Applicant: ANTHONY MAGLICA	)	Group Art Unit: 2901
Serial No. 07/411,576	)	Examiner: M. Tung
Filed: September 22, 1989	)	
For: FLASHLIGHT	)	
	)	
	)	
	)	
	)	
	)

AMENDMENT AFTER FINAL REJECTION

FIG. 1.

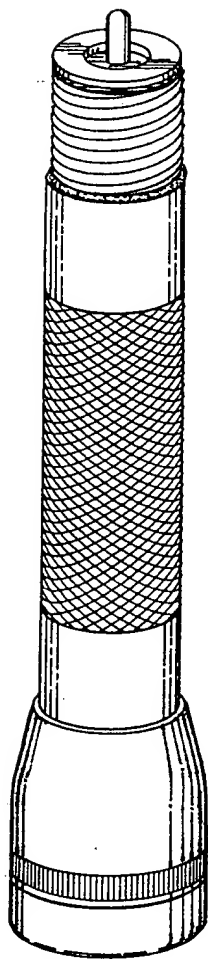
The treatment at the uppermost end as found in Figures 1 and 2 has also been varied. The outer flange of element 47 is shown above the threaded end of the barrel. This flange 47 is displaced slightly above the end of the barrel as can best be seen in Figure 3 of the original supporting drawings where the head assembly has been displaced sufficiently to show the at rest state of the flange 47 relative to the end of the barrel. Figure 8 is believed to show the same arrangement, albeit without sufficient clarity.
